City of Portland  
Development Review Application  
Planning Division Transmittal form

**Project Name:** SKATE PARK  
**Address:** Douglass St      **CBL:** 066 - A-002-001

**Project Description:** Skatepark; Doughty Field, Douglass Street; City of Portland,  
Hardcore Shotcrete Skateparks, Applicant.

**MINOR SITE PLAN DEVELOPMENT REVIEW**  
**Final review and sign off**

DOUGHTERY FIELD IMPROVEMENTS  
SKATE PARK AREA GRADING & DRAINAGE PLAN

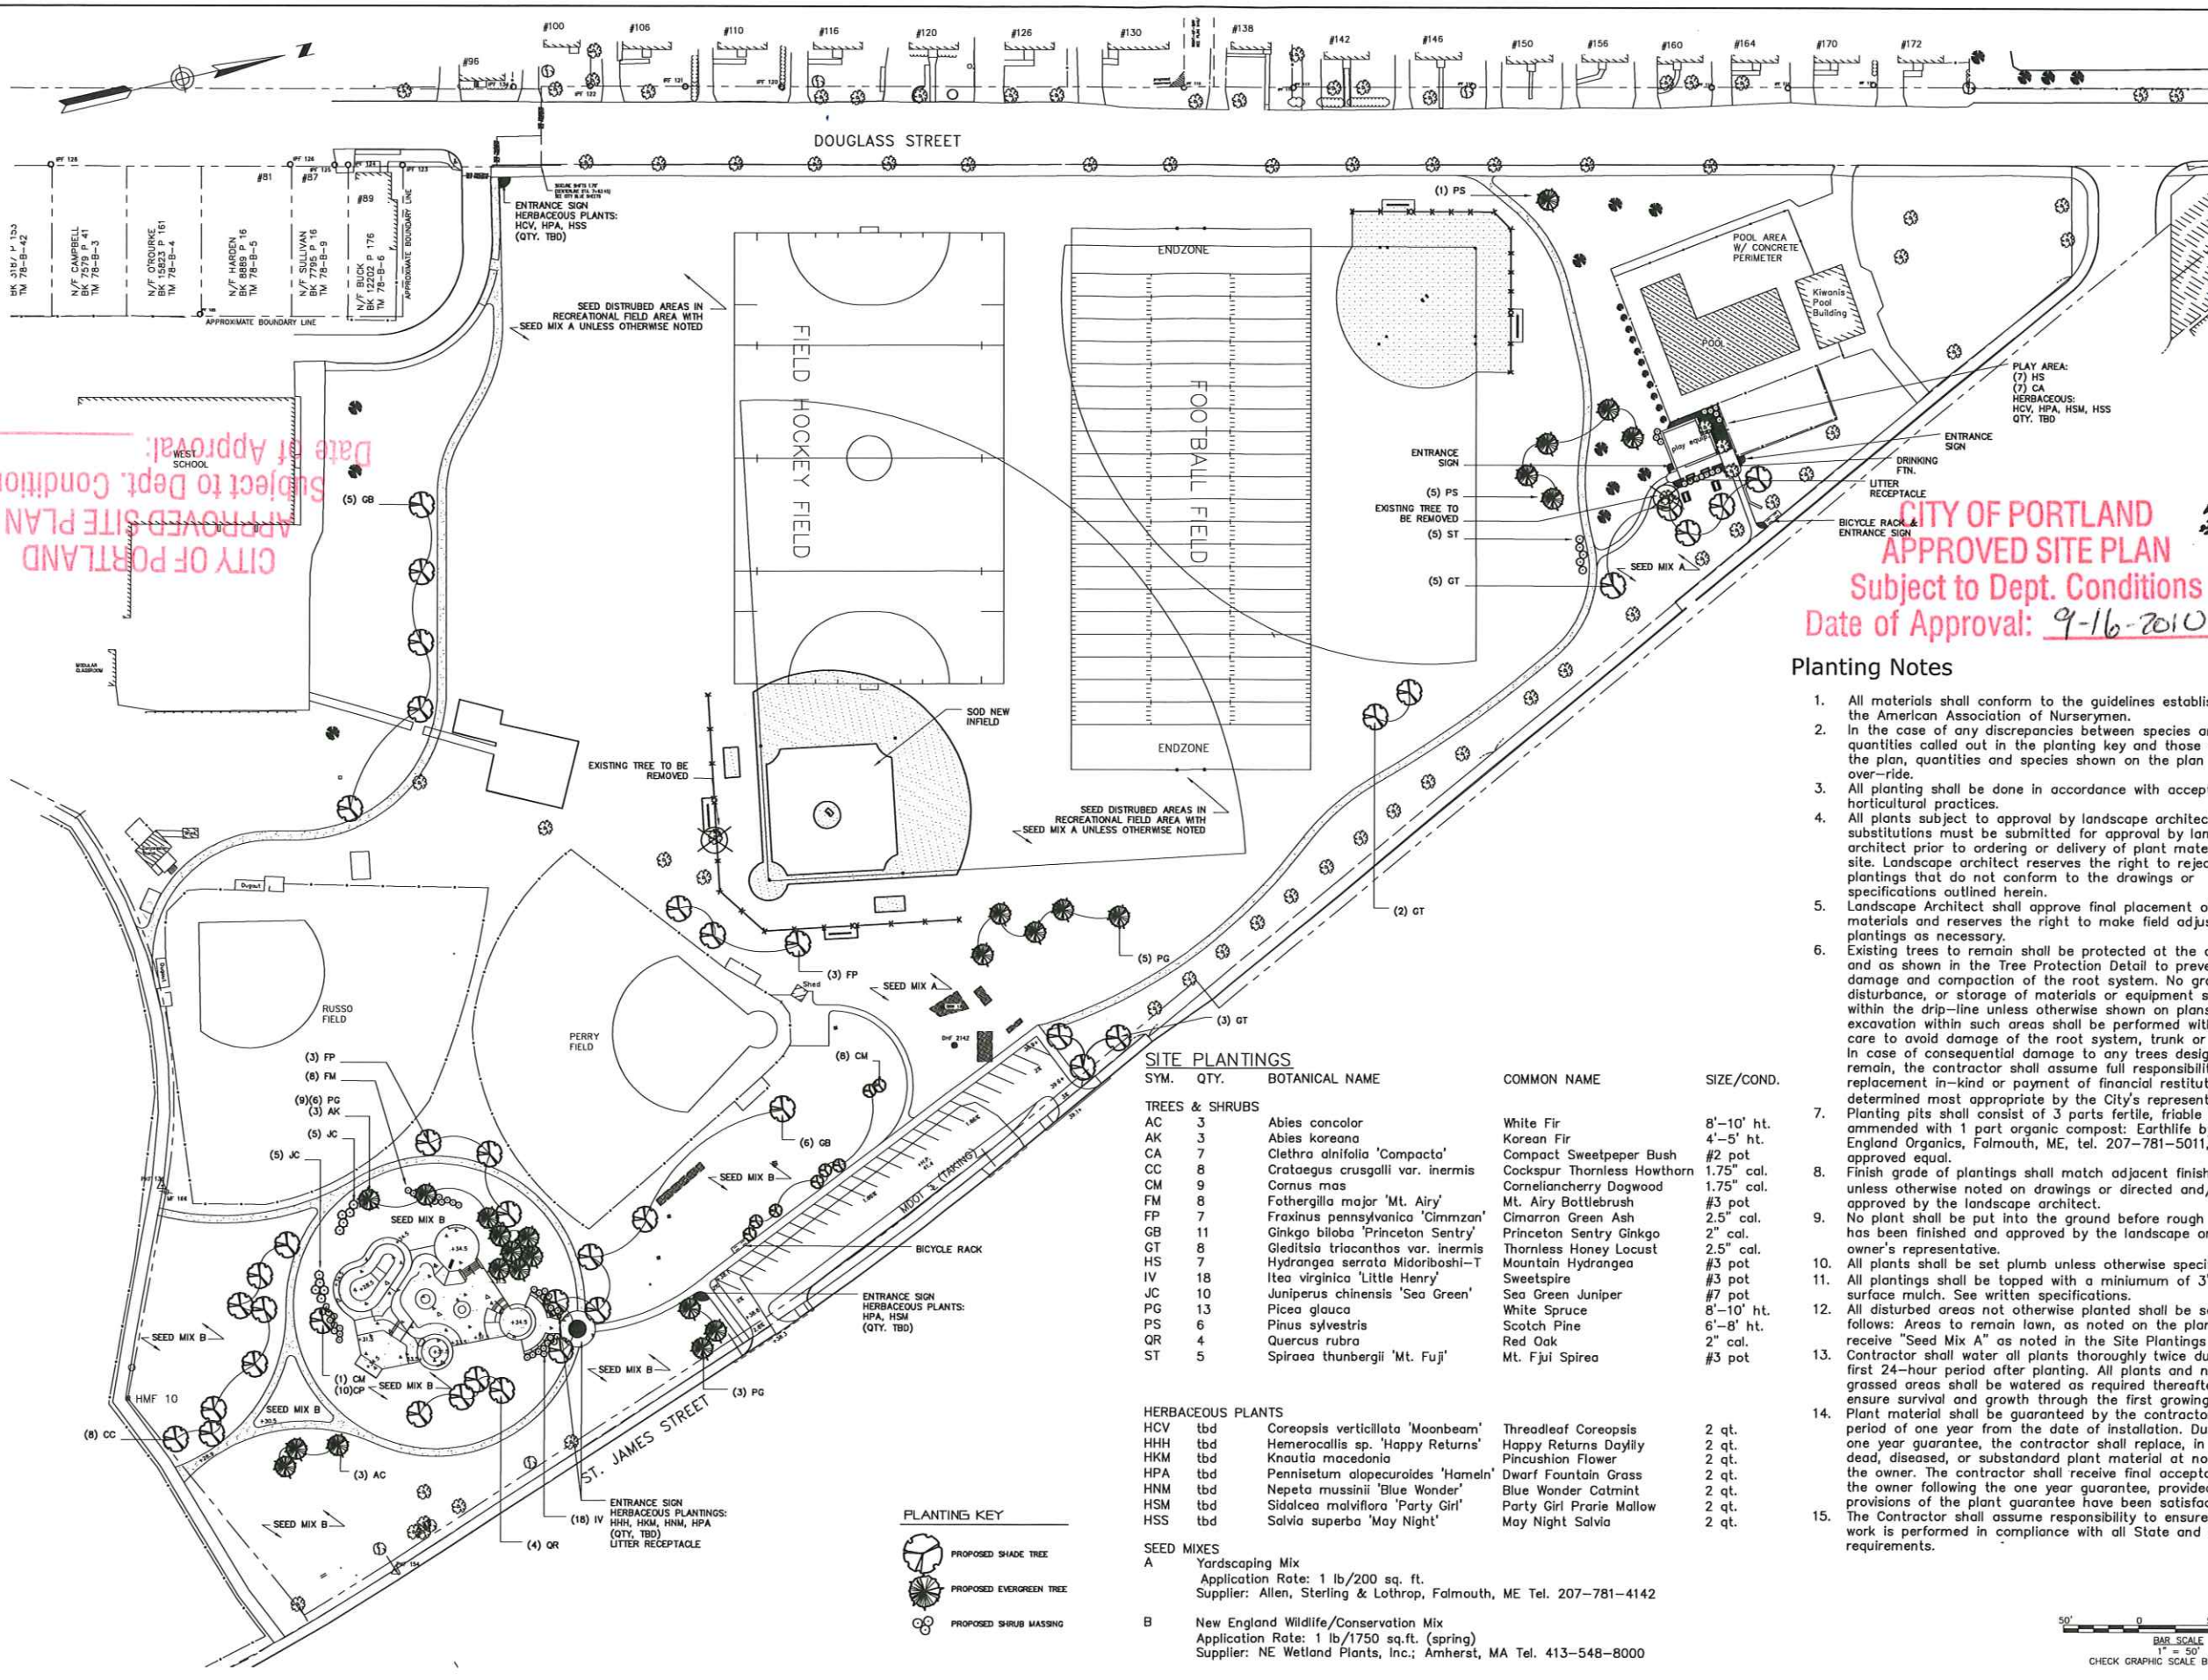
The revised plans (Woodard & Curran sheets #3 and #7) address the comments from our office's review of the storm water and permanent erosion control provisions for the overall design for the "Skateboard Park" area.

- >Sheet 3 of 9 - Updates to drainage to match Hardcore plan; update of plan notes to address temporary site stabilization (interim period between Hardcore's work & final grading).

1 TYP. TURF SWALE  
Scale: NONE

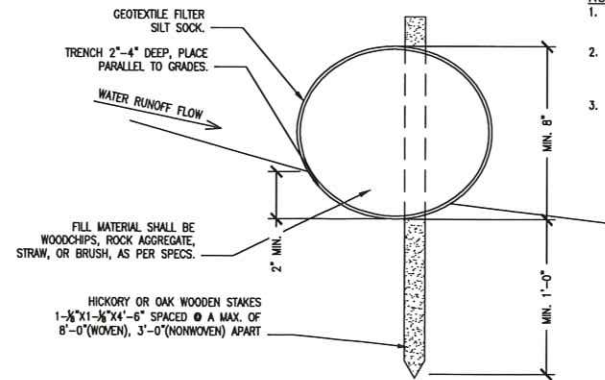
- It is unclear as to how disturbed areas outside of the skate park will be stabilized? Drawing SP-5A shows a Typ. Turf Swale detail that notes "Seed, Sod or Hyrdoseed, Refer to Specs.". No specifications were included in the packet. It would appear to be beneficial to specify whether seed or sod is proposed, and whether this treatment would apply to fill areas around the perimeter of the park in addition to any swales.
